Public Input No. 2428-NFPA 70-2023 [Global Input]

<u>File Name</u>	<u>Description</u>	<u>Approved</u>
PI_For_CMP_15_Voltage_Demarcation_.docx	Global PI for CMP 15 (Consistent Voltage Demarcation)

Statement of Problem and Substantiation for Public Input

Figure Informational Note Figure 517.31(B)(1) Type 1 Essential Electrical System — Minimum Requirement (Greater Than 150 kVA) for Transfer Switch Arrangement.

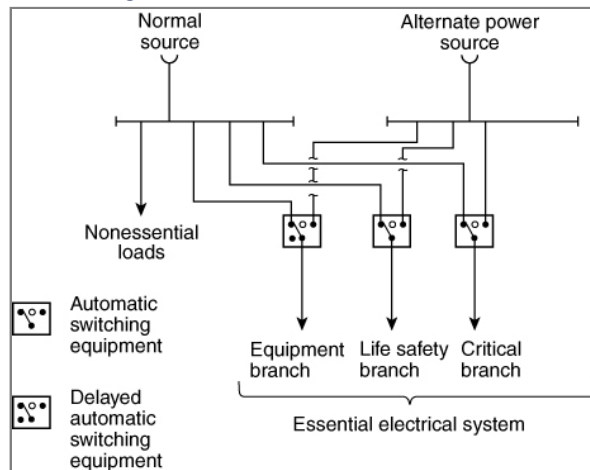
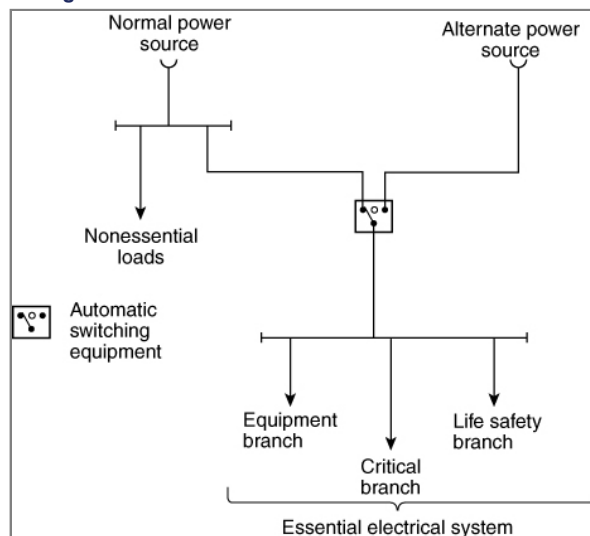
There is a potential for this to be misinterpreted. By stating that the threshold for requiring multiple transfer switches is the facilities essential electrical system load, it clarifies that the individual ATS sizing does not drive the need for multiple ATSs but the overall EES load is the driving factor. It appears that this was the intent of the code section as written. We recommend this change to avoid confusion on code interpretation. (Similar to 2110 for SNF's)

Figure Informational Note Figure 517.31(B)(1) Type 1 Essential Electrical System — Minimum Requirement (Greater Than 150 kVA) for Transfer Switch Arrangement:

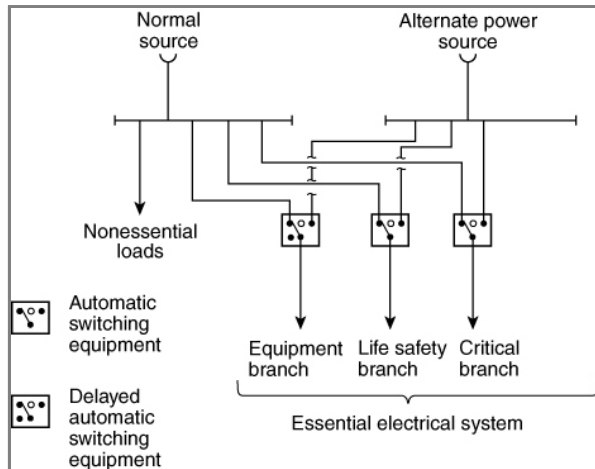
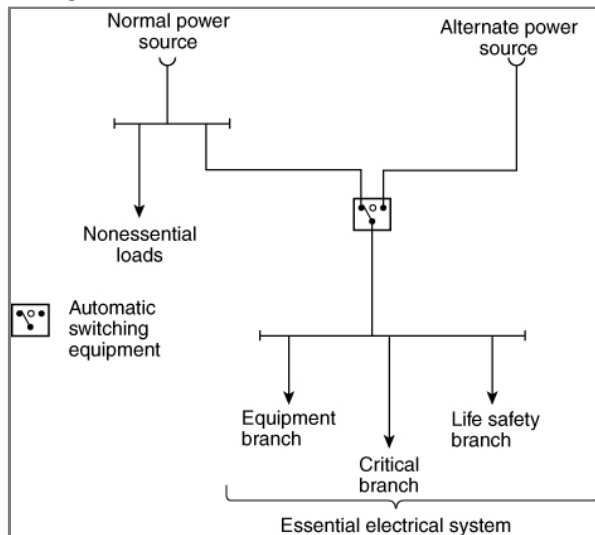
This PI includes two important changes. The first restates the one transfer switch rule with a better description of the capacity, and the recognition that one "branch" is sufficient for these small facilities.

Figure Informational Note Figure 517.42(B)(1) Type 2 Essential Electrical Systems (Nursing Home and Limited Health Care Facilities) — Minimum Requirement (Greater Than 150 kVA) for Transfer Switch Arrangement.

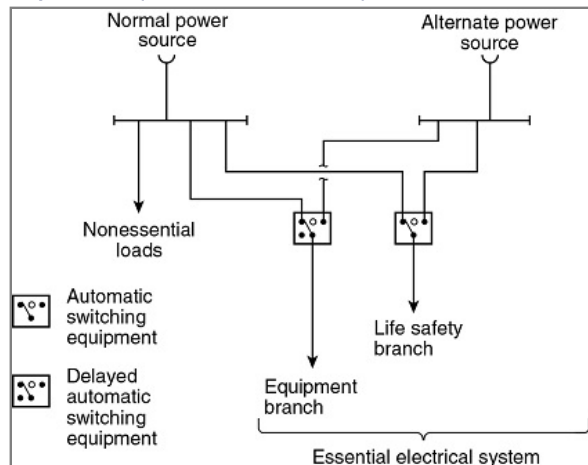
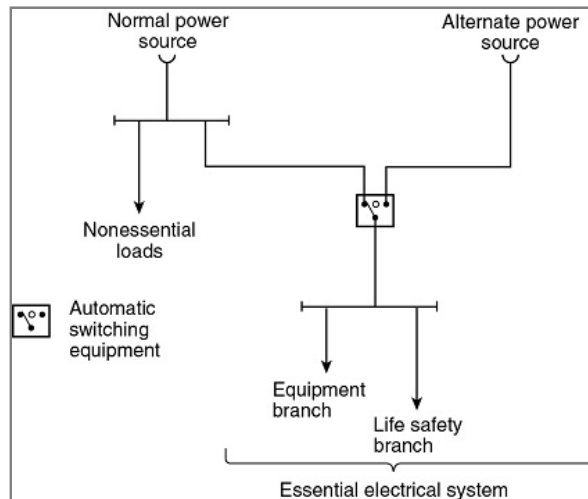
There is a potential for this to be misinterpreted. By stating that the threshold for requiring multiple transfer switches is the facilities essential electrical system load, it clarifies that the individual ATS sizing does not drive the need for multiple ATSs but the overall EES load is the driving factor. It appears that this was the intent of the code section as written. We recommend this change to avoid confusion on code interpretation. (Similar to 2109 for Hospitals)

Figure Informational Note Figure 517.42(B)(1) Type 2 Essential Electrical Systems (Nursing Home and Limited Health Care Facilities) — Minimum Requirement (Greater Than 150 kVA) for Transfer Switch Arrangement.

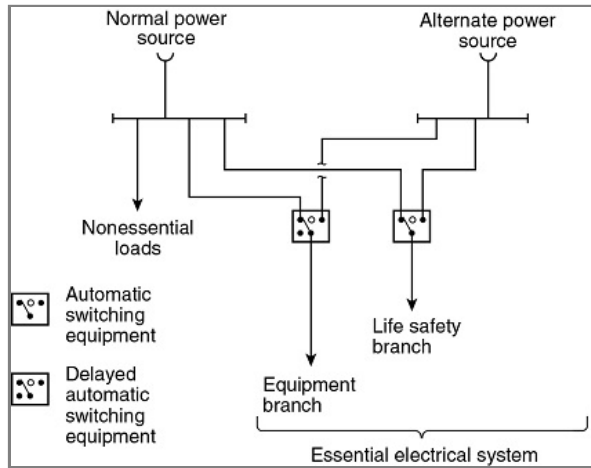
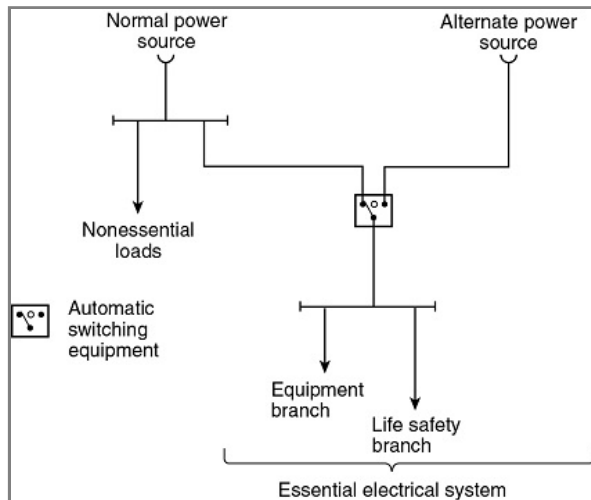
i think these diagrams should be replaced by the one in 2515; or, if we want to keep them here, modify to coordinate.
